5210 FUN-KART ENGINE DRIVE BELT

TSB165

Models affected: 5210 units assembled prior to 7/3/2014.

fig. 1

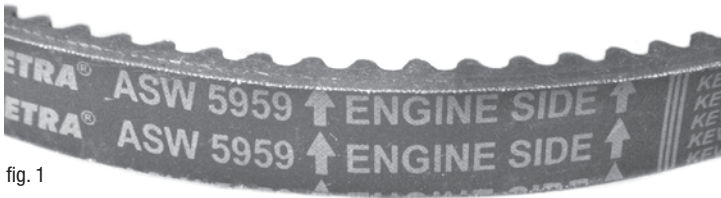
Identifying the issue: Look at the part number noted on the belt. If the part number is 5959 as shown in figure 1, this Technical Service Bulletin applies.

Solution: Replace 5959 belt with the 14704 belt.

fig. 2

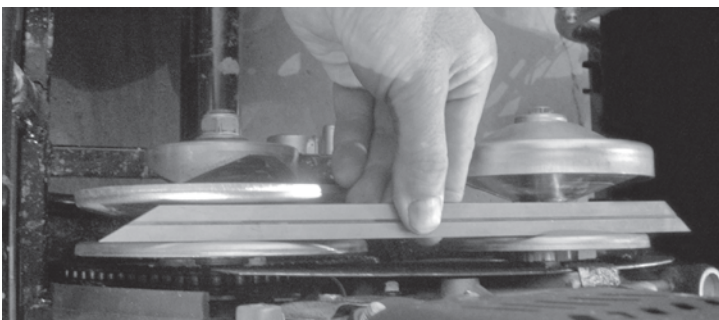
4. Check the alignment of the fixed sheaves of the driver and driven pulley using a straightedge as shown in figure 2. Adjust the driver out board, if needed, by installing a 3/4" washer behind the driver.

fig. 4

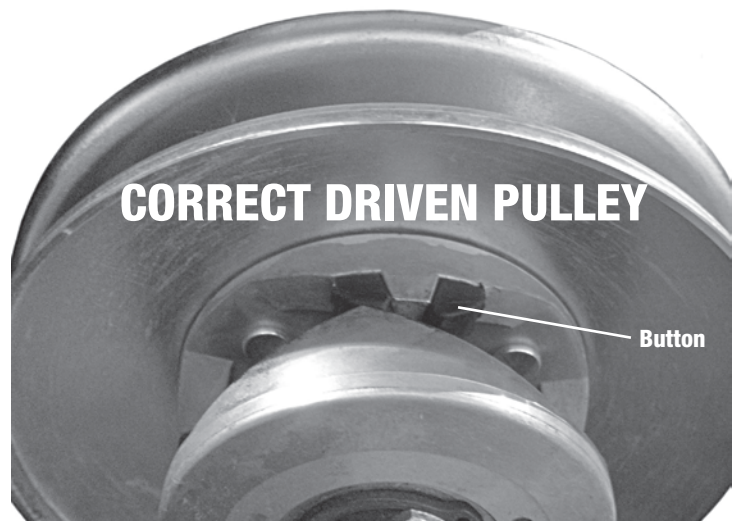
1. Remove the belt guard and then the belt with part number 5959.
2. Inspect all components to determine if any other items need to be repaired or replaced and do so as necessary. Inspect the driven pulley to make certain all buttons are present (quantity of 6) and the two halves of the pulley are indexed correctly as shown in figures 3 and 4.

fig. 5

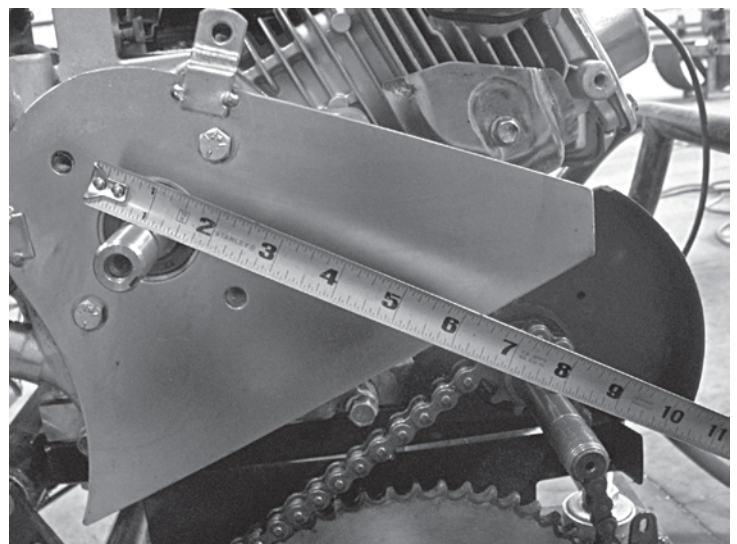
3. Confirm the distance from the center of the engine output shaft to the center of the jackshaft. This distance should be 180 mm / 7.1" as shown in figure 5.
